**Case: The Harrison Avenue Building, 2309
Harrison Avenue NW, 23-3283**

**CONCEPTUAL AND DETAIL DESIGN REVIEW
STAFF REPORT
November 30, 2023**

Project Name/Number:	The Harrison Avenue Building
Applicant:	Harrison Ave Caves LLC, Aaron Borden
Representative:	Olympic Engineering and Consulting, Chris Merritt
Project Location:	2309 Harrison Avenue NW
Project Description:	New proposed 2-story mixed use building with retail/office uses on the ground floor and 6 residential units provided on the 2 nd story. See Design Review Packet, page one for more details.
Zoning District:	High Density Corridor 3 (HDC-3)
Design Districts:	High Density Corridor
Comprehensive Plan Designations:	Urban Corridor, High Density Residential
Scenic Vista:	None
City Staff:	Paula Smith, Associate Planner Phone: 360.753.8596 E-mail: psmith@ci.olympia.wa.us
Public Notification:	In accordance with the Olympia Municipal Code (OMC) 18.70.040, public notification was mailed on November 7, 2023, to property owners within 300 feet of the site, parties of record and applicable recognized neighborhood associations.

Drawing:
LANDSCAPE
PLAN

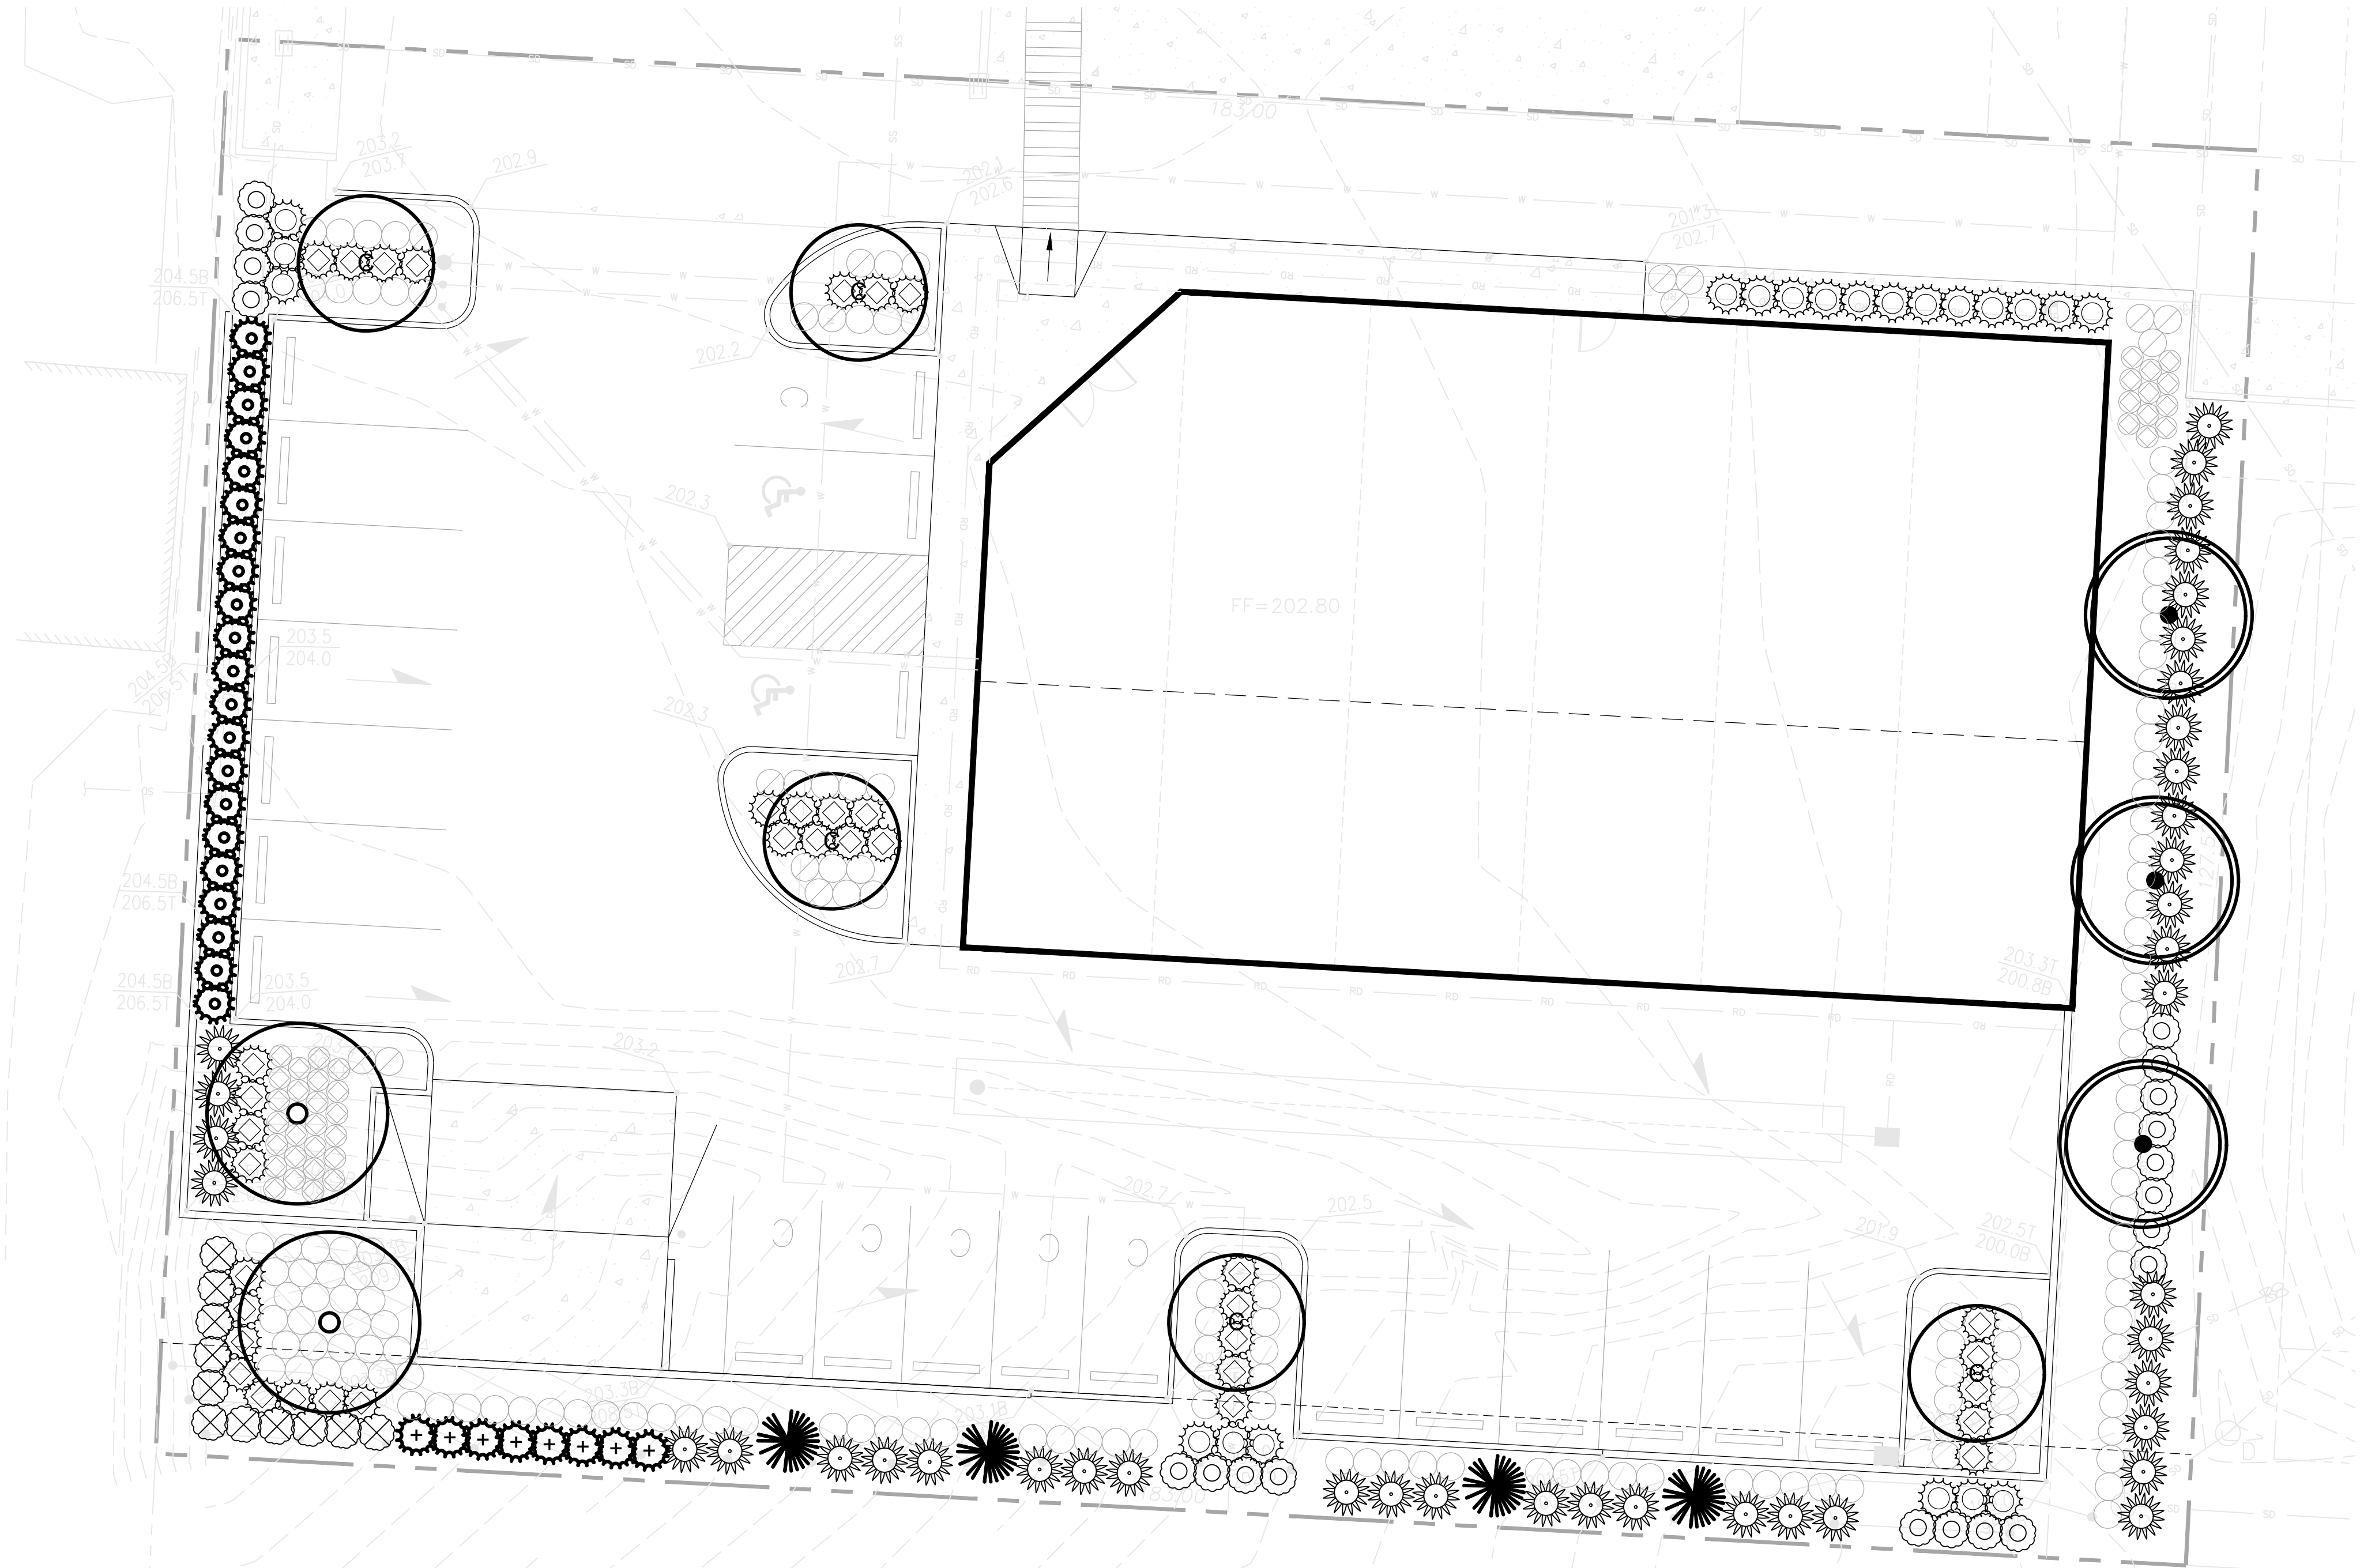
1. Plant Selection- Per OMC 180.110.180- Requires plants to be compatible with planting conditions. The perimeter landscaping on the west boundary will need to be modified and the tree species changed to meet perimeter landscaping and tree density per the land use review comments. The Landscaping Plan will be required to be revised to meet this design review criteria.

Staff Response: Changes to the perimeter landscaping along the western boundaries and changes in tree species are needed as a requirement of the land use review process in order to meet perimeter landscaping and tree density requirement. The City's Urban Forester approves all tree species. At this time the landscaping plan will need to be revised and resubmitted for land use review. Plant selection of other landscaping (not trees) appears to be appropriate that are provided on the plans. *Staff recommends that the applicant provide similar plantings found on the landscaping plan and incorporate those into the western perimeter to meet the requirement and that the applicant consult with the City's Urban Forester for tree species recommendations. A condition of approval for the Boards consideration has been provided in the staff report that appropriate plant selections to be verified at time of civil engineering review.*

Revise the landscaping plan that will provide appropriate plantings similar to the plantings (not trees) found on the existing landscaping plan and incorporate those plantings along the western property boundary instead of what is proposed. Provide this revised landscaping plan at time of resubmittal of the land use review documents for staff to review.
